Supplemental Information Inquiry #1

Project: Mankato to Mississippi River Project

23-157

Supplemental Information Inquiry 2

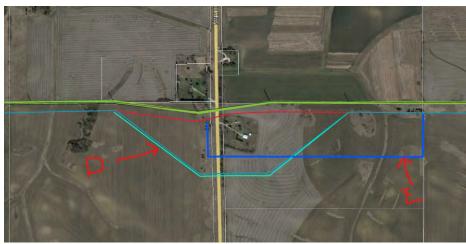
3. This request pertains to Route Segment 12 (CapX Co-Locate). Based on clarification provided by Dale Thomforde via email received on 10/19/2024, the alignment for this alternative was modified to go south of the property located east of County Highway 63. As discussed in a meeting between Xcel and EERA held on 10/22/2024, this was the original intent in Mr. Thomforde's proposed alternative as outlined in his 7/30/2024 scoping comment. As such, the alignment will be modified to reflect his original described alternative. EERA requested that Xcel propose a wider route width in this area to accommodate Mr. Thomforde's request and to also allow for flexibility should the Commission select this alternative but opt to keep the line parallel the existing line. Xcel provided an updated kmz via email on 10/24/2024. Within this kmz, the requested wider route width was provided and labeled in the kmz as "MMRT_PUC_NotificationArea_20241022." At the eastern end of the corrected alignment, the route width is shown wider as requested but also extends approximately a 0.2 mile to the east. Please provide an explanation of why the route width extends approximately a 0.2 mile to the east from the alignment.

Similar answer as to question 2 above: The route width is extended wider to accommodate a potential alignment that Ellen Heine provided to Dale Thomforde and Rich Davis in an email on 10/18/24, prior to receiving Dale's update/correction, as shown in the first screenshot below. Dale responded to that email with a change in what Ellen had provided. Dale's proposed alignment does not follow parcel lines (see second screenshot below, options labeled D for Dale and E for Ellen). Our understanding was that Rich felt that we should include both options when developing the route width. If that understanding was incorrect the route can be adjusted in this area.

Figure 1

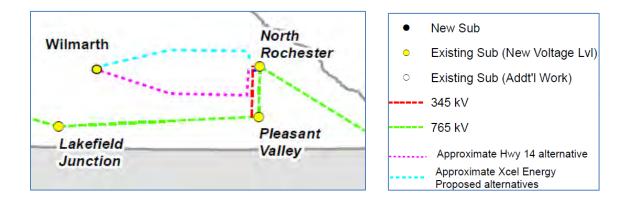
4. This request pertains to Route Segment 17 (Hwy 14 option). Xcel's August 28, 2024 letter responding to scoping comments noted the potential future need to connect to the West Faribault Substation. This was also noted in Xcel's route permit application (Section 2.7 Design Options to Accommodate Future Expansion). The potential connection of the project's 345 kV transmission line to the substation would serve the future purpose of connecting the lower voltage transmission system to the backbone (345 kV) transmission system. Your email dated 10/18/2024 to EERA reiterated: "The proposed alignments in our application did not connect at the West Faribault Substation, but routed close to it, based on the expectation that in the next several years it will be necessary to connect that sub to the 345 kV system. We are doing some more research to try to clarify when that would be needed, and what the alternative would be if the 345 isn't close (possible other system upgrades, etc.) but wanted to note that a Hwy 14 alignment may necessitate a future, additional 15ish mile 345 kV line (green circle in the screenshot below for approximate location) to connect to West Faribault." The screenshot provided by Xcel is shown below as Figure 1. Please provide an estimated construction timeline that Xcel would anticipate that the connection to the West Faribault Substation could be required and any updates on the potential for the 15-mile new transmission line and its necessity.

5. This request pertains to Route Segment 17 (Hwy 14 option). Xcel's August 28, 2024 letter responding to scoping comments states: "In addition, the Highway 14 would also require a new approximately 13-mile long 345 kV connection from the Byron Substation to the North Rochester Substation. There is already a 345 kV transmission line between these two substations such that this new 345 kV line could be double-circuited with the existing line. However, this area of the system is expected to require an additional 345 kV connection from the Byron Substation to the North Rochester Substation in the future and double-circuiting with this existing 345 kV line at this time would make this future 345 kV connection more difficult." Your email dated 10/18/2024 to EERA reiterated this point and circled the area in question in orange in Figure 1 above. For inclusion in the EIS, please provide addition detail of what would make the future 345 kV connection "more difficult." Please also provide an estimated construction timeline that Xcel would anticipate that the additional 345 kV line could be required.

The MISO Tranche 2.1 portfolio is expected to be approved in December 2024. That portfolio includes a new 345 kV transmission line from Pleasant Valley to North Rochester with an in-service date of 2032 (as well as a new 765 kV line from Lakefield Junction to Pleasant Valley to North Rochester to Columbia (in Madison, WI)). See screenshot below and the link to MISO's web site.

The Pleasant Valley to North Rochester project follows an existing 345 kV transmission line (line #0979) and assumes rebuilding that line to a double-circuit 345/345 kV line. If the Highway 14 alignment is selected for the MMRT Project the Byron to North Rochester portion of that option would involve double-circuiting with the existing line 0979. This would mean that it is no longer possible to double-circuit that portion of the upcoming LRTP Tranche 2.1 Pleasant Valley to North Rochester line with the existing line, as that position will be taken. This will necessitate finding a new route for the LRTP 2 Tranche 2.1 345 kV line. We have attempted to illustrate with some edits to the MISO map as shown below (note this does not show existing lines such as the existing Pleasant Valley to North Rochester 345 kV line).

System Illustrations for Supplemental Information Inquiry 2, Question 7

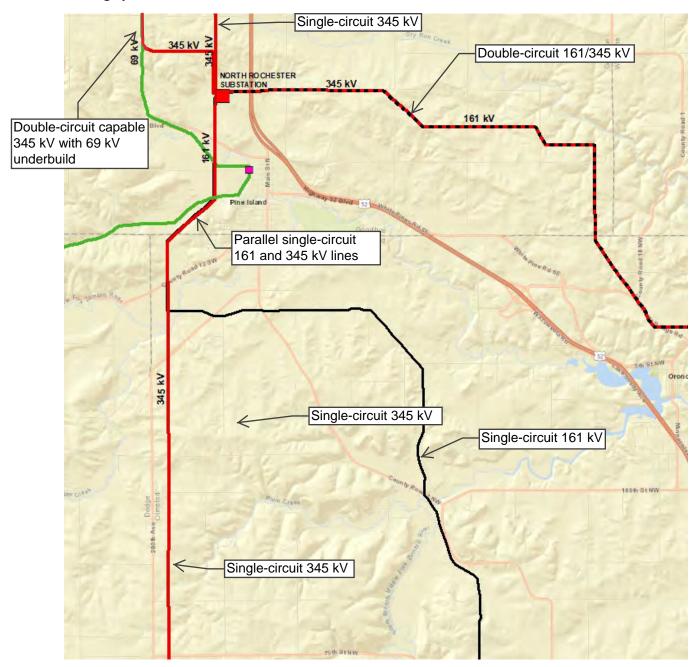
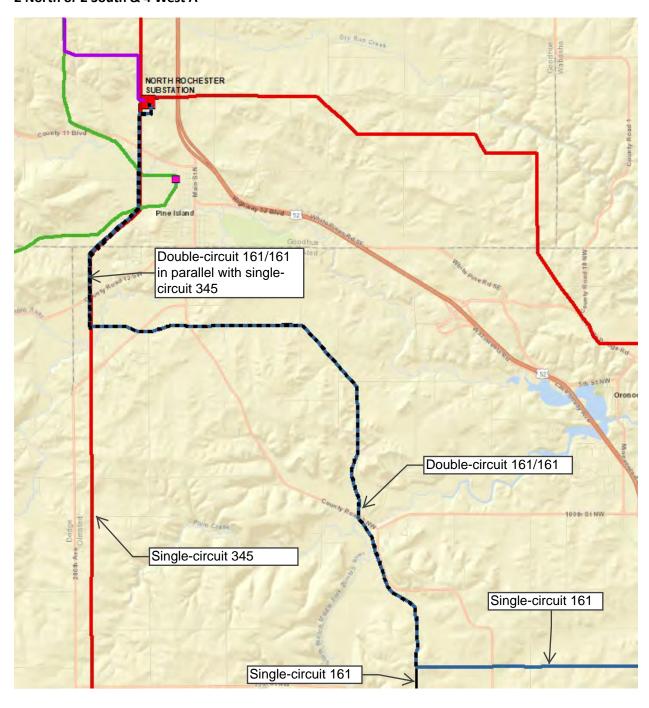
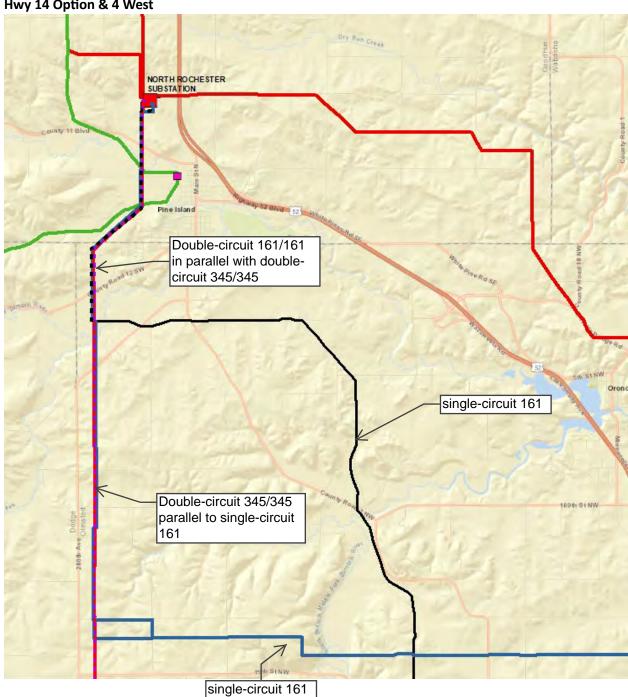
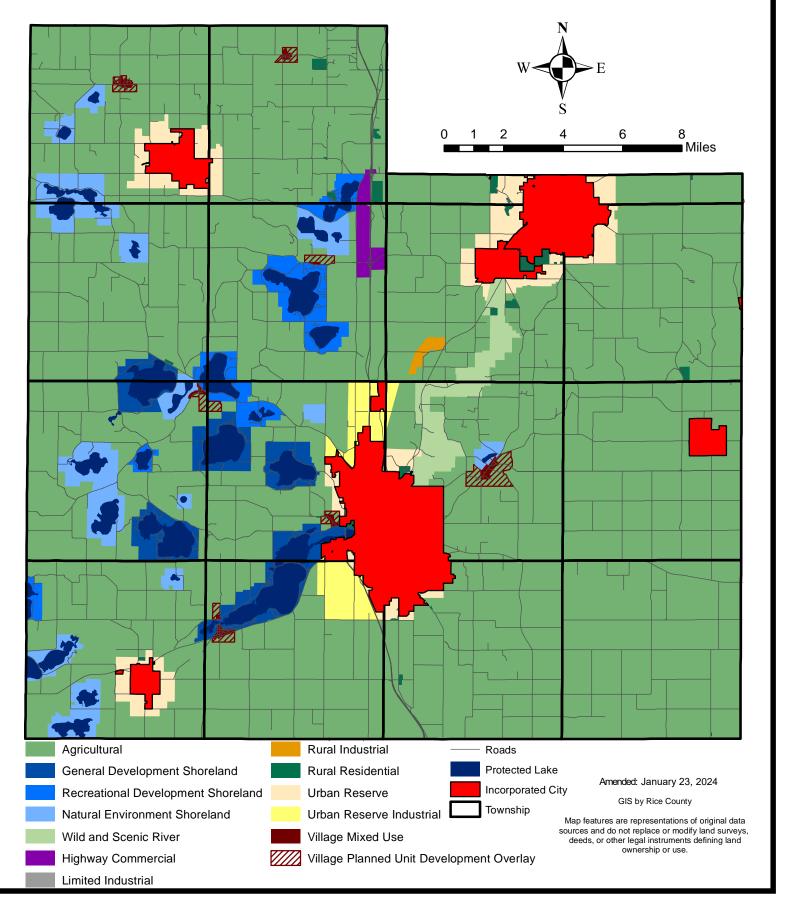
7. This request pertains to Route Segment 17 (Hwy 14 option). In a meeting between Xcel and EERA held on 10/02/2024, EERA and Xcel discussed means of defining an anticipated alignment for the Route Segment 17 (Hwy 14 option). Xcel reiterated that the Route Segment 17 (Hwy 14 option) would need to terminate at the North Rochester Substation (which is also where the applicant's proposed Segment 2 terminates). Xcel's August 28, 2024 letter also noted the need to terminate this alternative at the substation; specifically, your letter stated: "As the Project requires a connection to the North Rochester Substation, a Highway 14 Route Alternative (HWY 14-ALT) would need to also include a new 345 kV connection from the Byron Substation north to the North Rochester Substation." As discussed on 10/02/2024, it is EERA's understanding that should Segment 4 West (as proposed in RPA, this includes: 4K, 4L, 4N, 4H, 4O, 4P) be selected by the Commission as part of the final route, the anticipated route corridor for the portion of the Route Segment 17 (Hwy 14 option) going north/south between the Byron Substation and the North Rochester Substation would be one in the same as the north/south portion of Segment 4 West between the Byron Substation and the North Rochester Substation. Xcel noted this would imply that there could be two lines running north/south. Please confirm that two lines running north/south in this area would be constructable and feasible. Please also confirm if double circuiting is a potential in this area.

Segment 4 of the MMRT project includes the relocation of a portion of the 161 kV line between North Rochester and the Chester Substation (east of Rochester). No portion of the Segment 4 is proposed to be double-circuited with the existing 345 kV line (see question 5 above for more on this item). If Segment 4 West is selected approximately 3.3 miles of the new line would be double-circuited with the existing North Rochester to Northern Hills 161 kV line. If Route 4 West-A is selected approximately 11.3 miles would be double-circuited with the existing 161 kV line.

Note, there are a number of existing lines in this area that connect to the North Rochester Substation. The enclosed System Illustrations for Supplemental Information Inquiry 2, Question 7 shows the configuration and locations of the lines that would result from the project for the following potential route choice combinations:

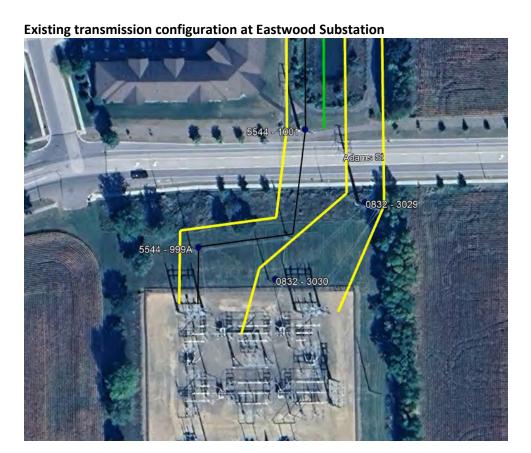
- The joint certificate of need application and route permit application indicates the Wilmarth Substation would be upgraded to include new substation equipment. It also notes the expansion area would be approximately 0.8 acre in size located on the northeast corner of the existing substation. To better understand potential impacts for the upgrades to this substation, please provide:
 - A shapefile showing the location of the 0.8-acre expansion area.
 Please see separately provided shapefiles of the Wilmarth Prelim Grading Concept (zip file WilmarthSub_Shapefiles_20250123.zip) of the proposed Wilmarth Substation expansion area.
 - Confirmation that the expansion area and access to it would be on Xcel-owned property.

Xcel Energy confirms that the expansion area and access to it will be on Xcel Energy (NSPM)-owned property (also see separately provided shapefile WilmarthSub_Parcels within above referenced zip file for property boundaries).

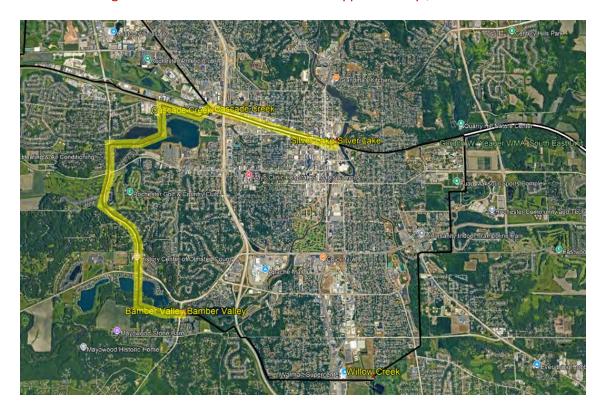
10. This question pertains to the Chester Junction Substation Alternative. In Xcel's response to EIS scoping comments, Xcel stated that three 161 kV lines would need to be rebuilt to a higher capacity to avoid overloads. Which three 161 kV lines, specifically, would need to be rebuilt to a higher capacity and what would that capacity need to be? Please provide a map or shapefile of their locations.

The line rebuild segments are as follows and shown in the screenshot below and attached shapefiles (ChesterJunction_161kV_Rebuilds_20250124.zip)

- Crosstown to Cascade 161 kV line will need to be rebuilt to a minimum of 1500 Amps, depending on conductor type and input from Rochester Public Utilities (RPU). This existing line is approximately 1.21 miles in length and the cost to rebuild this line is approximately \$4.8 million.
- Crosstown to Silver Lake 161 kV line will need to be rebuilt to a minimum of 1500 Amps, depending on conductor type and input from RPU. This existing line is approximately 0.36 miles in length and the cost to rebuild this line is approximately \$1.8 million.

• Cascade to Bamber 161 kV line will need to be rebuilt to between 1000-2000 Amps, depending on conductor type and input from RPU. This existing line is approximately 4.33 miles in length and the cost to rebuild this line is approximately \$10.8 million.
